CONSULTATION REPORT

Melton Mowbray Distributor Road

Melton Mowbray Distributor Road Consultation

November 8, 2017

Figure 1. Recommended route

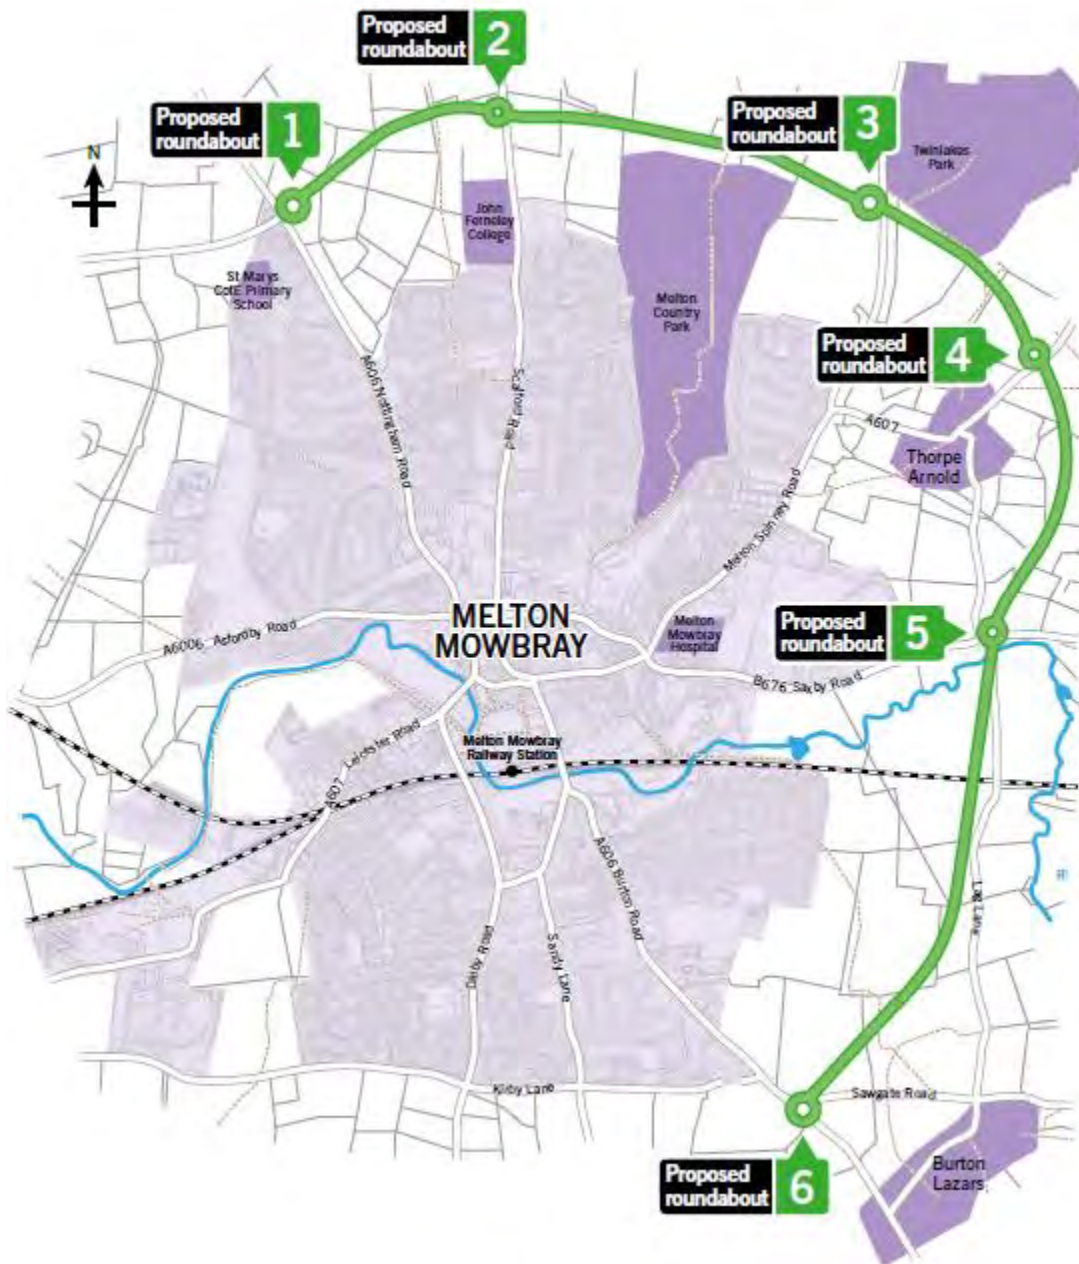
- Won't help Leicester road traffic (11 mentions), typical comments included:
 - "It won't help the traffic that comes from Leicester road."* Online response form (Respondent 59)

- "It does not address the issues of traffic to and from Leicester road leaving and arriving in the town."* Online response form (Respondent 77)
 - "The proposed distributor road excludes the busiest road into Melton from Leicester."* Online response form (Respondent 131)

- "Will not relieve traffic on 607 road traffic will still got through town as bypass is a road to nowhere. no-starter unless linked to Leicester road."* Paper response form (Respondent 151)

- Won't solve problem (9 mentions)
 - "Melton is just a cross roads for two major roads, the 606 and 607 by building a link on just one will not solve the problem in Melton."* Online response form (Respondent 49)

- Southern distributor road needed (14 mentions)
"The proposal route is incomplete without connecting the relief road from the Oakham Road to the Leicester Road." Paper response form (Respondent 145)

"But strongly suggest that the route between the A606 Burton Road/Oakham Road and A607 Leicester Road (Southern Distributor Road) is also included or secured by other means." Online response form (Respondent 212)

Figure 14. Proposed junction locations

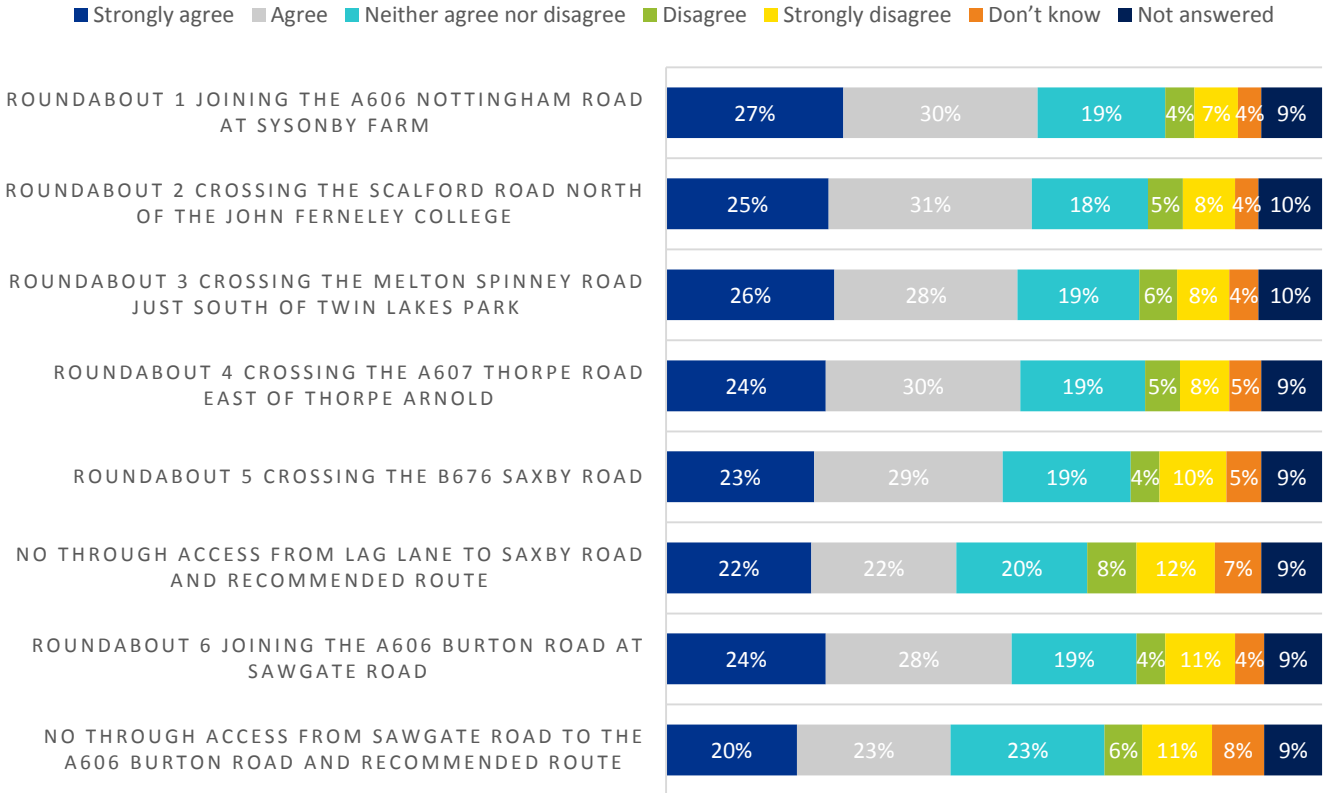
- Sawgate Lane/Lag Lane, mentioned by 32 respondents. The main issues within this were:
 - NMU access to Sawgate Lane/Lag lane (7 mentions)
"I hope that access via Lag Lane and Sawgate road will still be possible by foot, cycle and horse, but this is not clear from the plans available at the moment." Online response form (Respondent 70)

"Lag Lane and Sawgate Rd are popular with dog walkers, runners and cyclists (myself included in all three of these). I'm concerned about the impact that the route will have on the junctions specified above for these users. It would be a great shame if access was reduced or made less NMU friendly by the construction work." Online response form (Respondent 110)
 - Antisocial behaviour/ fly tipping (6 mentions)
"Creation of a dead end would also encourage more fly tipping." Online response form (Respondent 184)
 - Why no access to Sawgate/Lag Lane? (4 mentions)
 - Happy with no through access (4 mentions)
- General support (mentioned by 27 respondents)

- Roundabout OK/best/safest/improve environmental impact/keeps traffic out of town/ helps flow of traffic/logical (9 mentions)
"Traffic roundabouts will slow the traffic but also keep it moving." Online response form (Respondent 12)

"They are good ways of joining everything up." Online response form (Respondent 172)

"The positioning of the roundabouts keep the traffic clear of the town. A huge percentage of traffic entering MM is purely passing through." Online response form (Respondent 46)
- Agree with route/ junction designs (7 mentions)
"The locations look reasonable, and I would agree with no access from Lag Lane or Sawgate Road for motorised traffic." Online response form (Respondent 197)

"The general layout seems well thought out and needs no modifications." Online response form (Respondent 71)
- Opposition (17 mentions)
 - Disagree with route (6 mentions)
 - Blocks NMU routes (4 mentions)
 - Too close to Melton Country Park (2 mentions)
- Other route (14 mentions)
 - Full bypass (6 mentions)
 - Western route (4 mentions)
- Roundabout 2 (13 mentions)
 - Scalford road not designed for through traffic (3 mentions)
"Scalford road isn't designed for a lot of through traffic." Paper response form (Respondent 99)
 - Extend further north (2 mentions)
- Roundabout 3 (10 mentions)
 - Ok/ good location (2 mentions)
 - Dedicated filter lane for Twin Lakes (1 mention)
 - Reduce speed limit to 50mph (1 mention)
- Roundabout 6 (10 mentions)
 - Move north/south (2 mentions)
 - Realign for direct route between Saxby Road and Burton Road (1 mention)
